Palm Court Retail Center Revised Sign Program Project Description

#### WALNUT CREEK DESIGN REVIEW COMMISSION RESOLUTION NO. 1490 DESIGN REVIEW APPLICATION NO. 8927 PETTICOAT LANE SHOPPING CENTER RENOVATION (PALM COURT)

#### WALNUT CREEK DESIGN REVIEW COMMISSION RESOLUTION NO. 1870 SIGN REVIEW APPLICATION NO. 92-32/0434 TRAVEX SIGN EXCEPTION

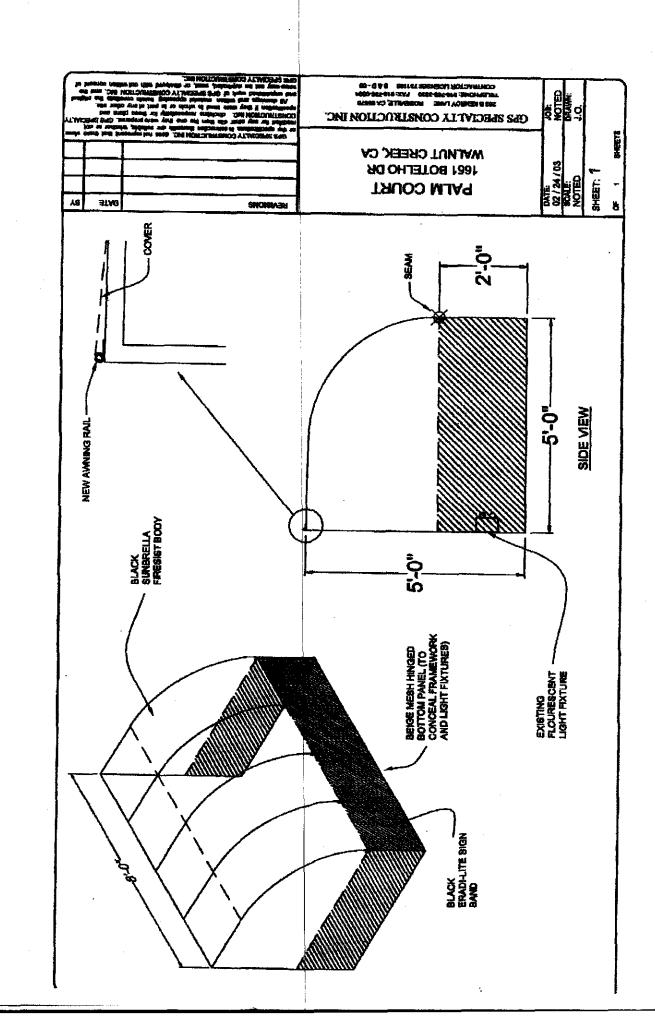
- 1) Main body of Palm Court Retail Center will be SW6114 "Bagel".
- 2) The vertical & horizontal columns will be SW6108 "Latte".
